TECHNICAL STAFF REPORT Lawyers Hill Overlook

Planning Board Quasi-Judicial Public Hearing of June 6, 2019

PB Case No. 445 Lawyers Hill Overlook / Land Design and Development,

SP-19-002 Lawyers Hill Overlook, Lots 1-17 & Open Space Lot 18

TITLE SHEET

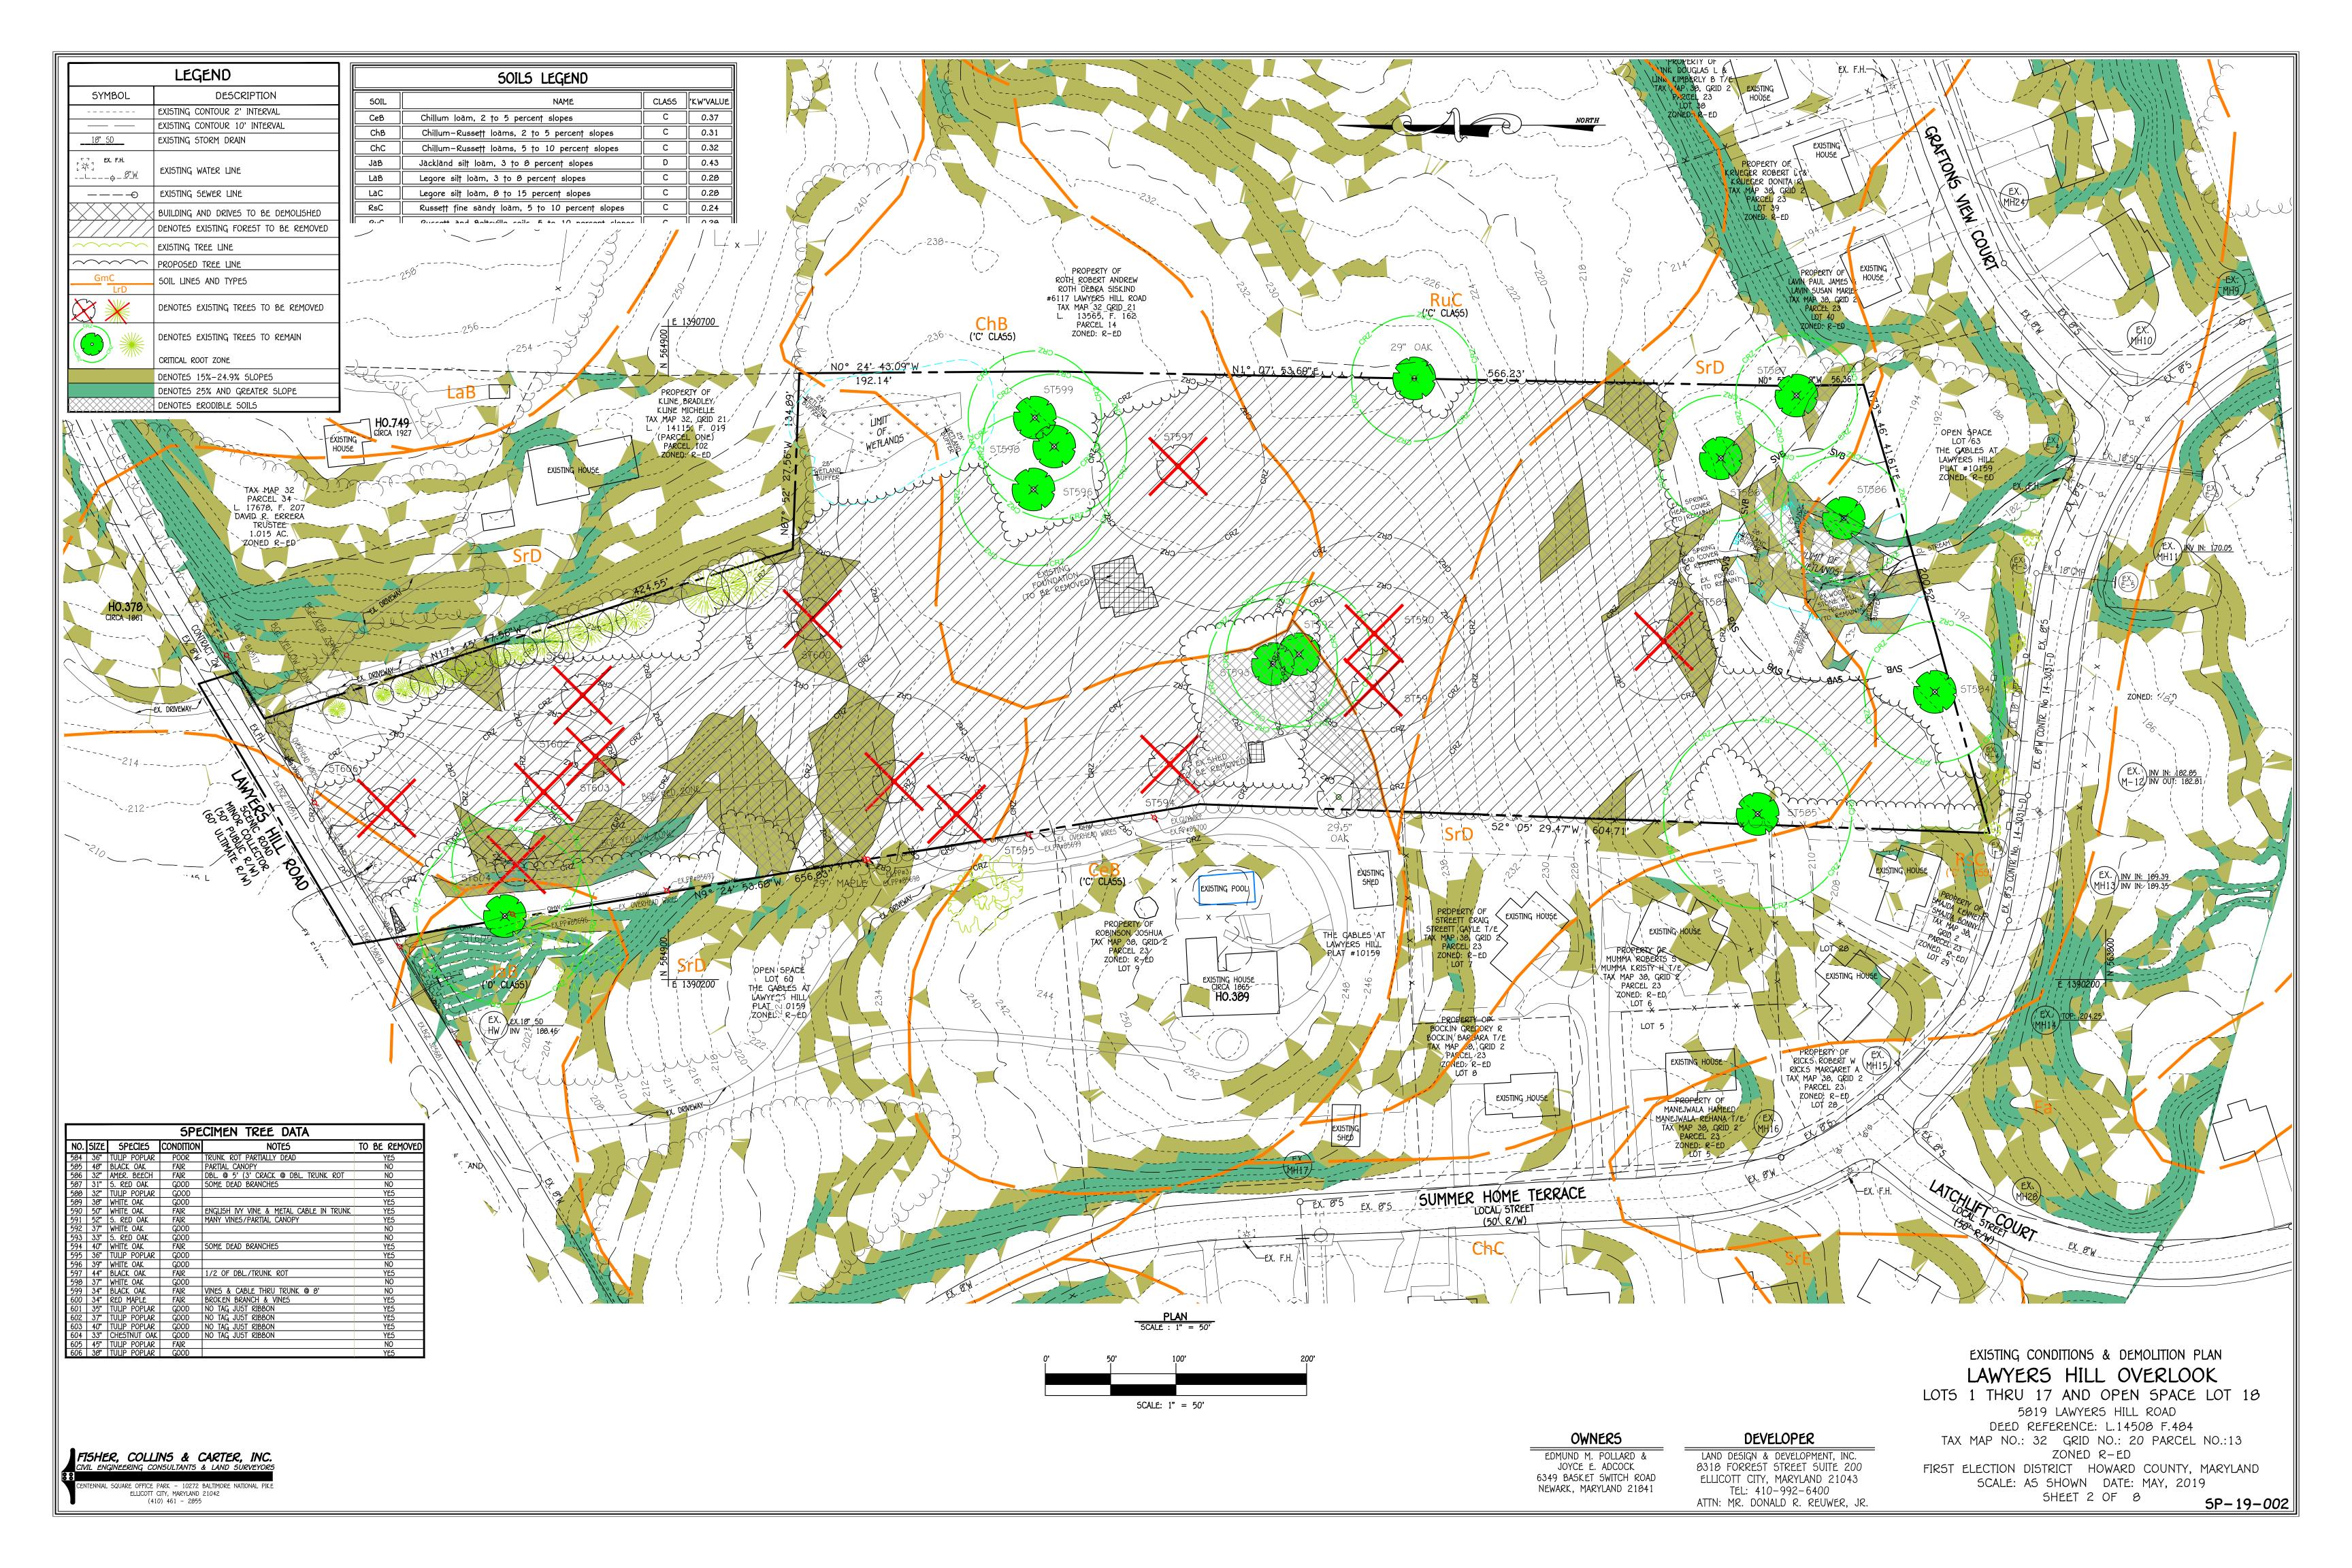
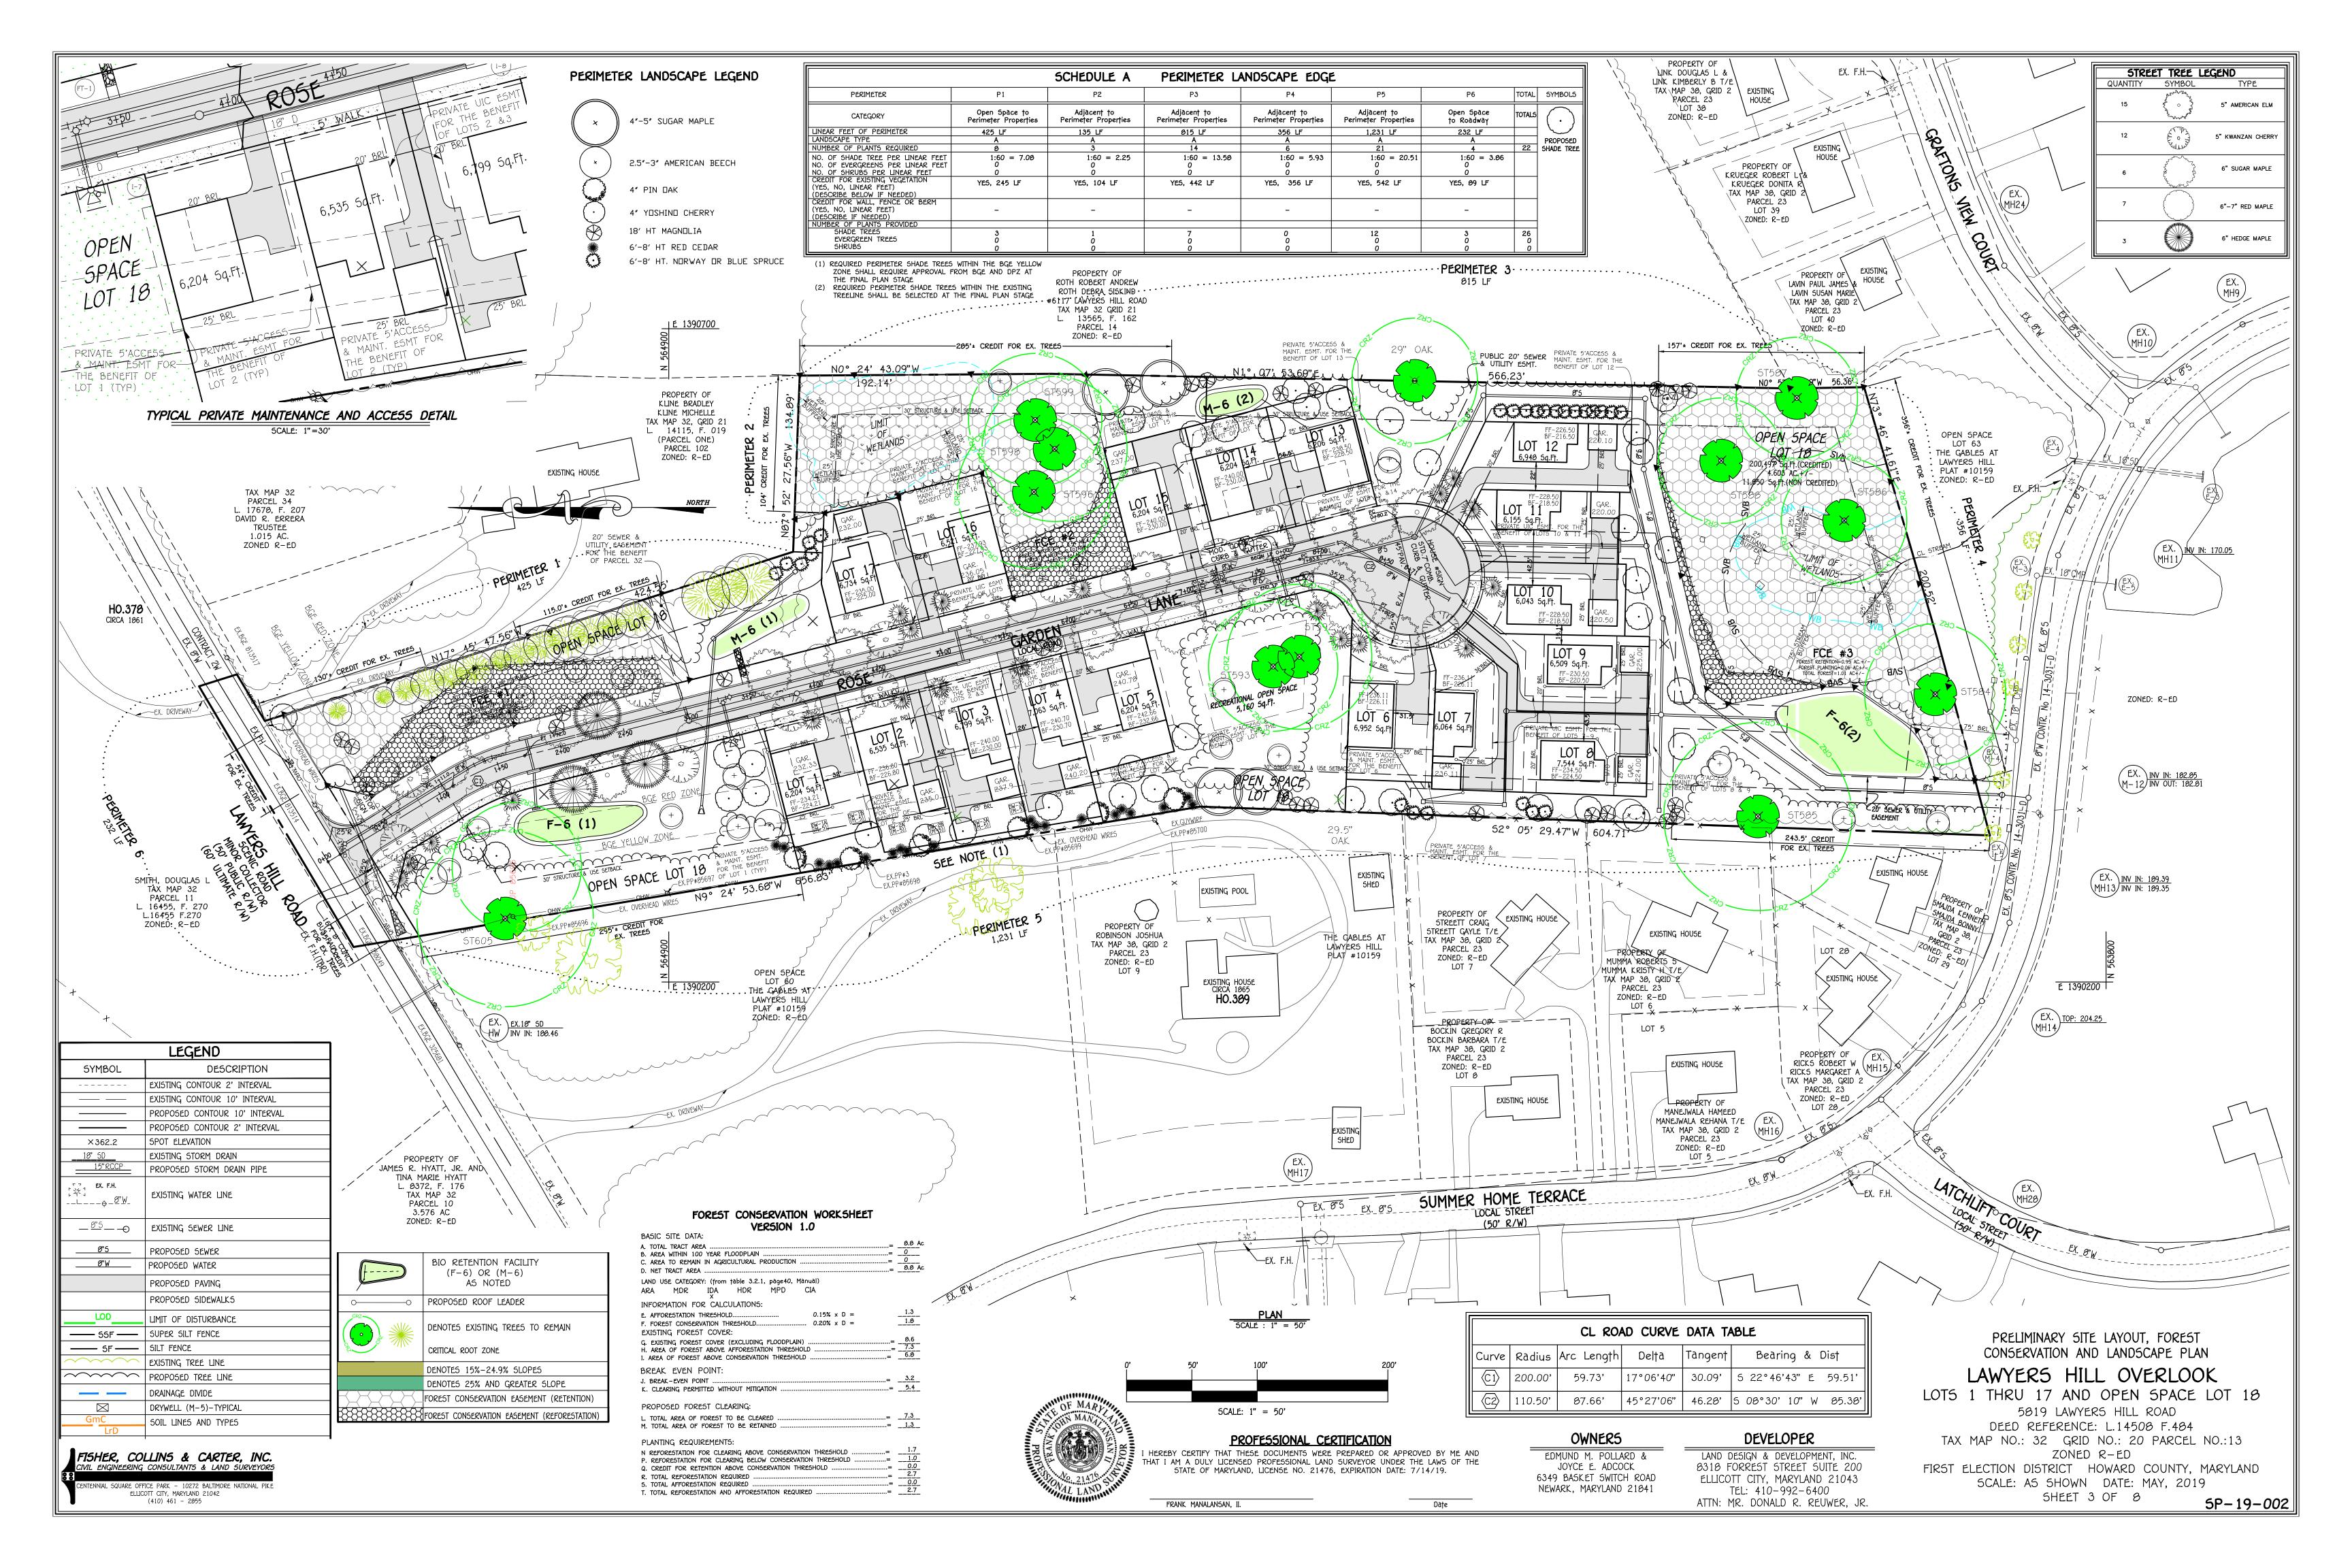
Mr. Reich stated that the plans showed a row of trees along the entry road and scattered deciduous trees around the perimeter of the houses. Mr. Reich asked which specimen trees were getting saved. Mr. Reich pointed to parts of the plan for Mr. Reuwer to confirm trees that were being saved. Mr. Reich asked about the evergreen trees on the plan. Mr. Reuwer stated those trees were being added and stated they were proposing to have trees to keep anyone who did not want to see the subdivision from seeing it. Mr. Reuwer said the stormwater management plan was tweaked so the evergreen trees by Ms. Kline's property would remain and not be removed. Mr. Reich stated it seemed on the south side by the Robinson house, the buffer was sparse. Mr. Reuwer said he was putting a thick buffer around the subdivision and was happy to have a thicker buffer in that open space. Mr. Reuwer stated he had a 30-foot setback that allowed for that.

Mr. Taylor asked if the specimen tree plan showed all of the trees. Mr. Reuwer said it did. Ms. Burgess clarified it showed all trees 30 inches in diameter or greater. Mr. Reuwer stated that was the definition of a specimen tree. Mr. Reich confirmed that there were 23 specimen trees on the specimen tree list and they matched the specimen trees shown on the plan. Mr. Shad confirmed that the plan and tree list matched.

Mr. Roth stated the preliminary sketch plan provided by the Applicant does not show either of the historic resources identified by the Commission in the advisory comments from April 2018. Mr. Roth advised that it should be revised before the Department of Planning and Zoning undertakes any further consideration of the proposal.

Mr. Roth stated the preliminary sketch plan provided by the Applicant does not show either of the historic resources identified by the Commission in the advisory comments from April 2018. Mr. Roth advised that it should be revised before the Department of Planning and Zoning undertakes any further consideration of the proposal.

- Relocated Open Space Lots to provide enhanced screening of the neighboring historic home known as The Gables (HO 389).
- Relocated several buildable lots to save more specimen trees.
- Modified the garage location to be either side loaded or detached and located behind the homes.
- Selected street tree species, location, and sizes to replicate the patterns found in the Lawyers Hill Historic District.
- Located the existing historic well house on a proposed Open Space Lot to help protect and buffer it.
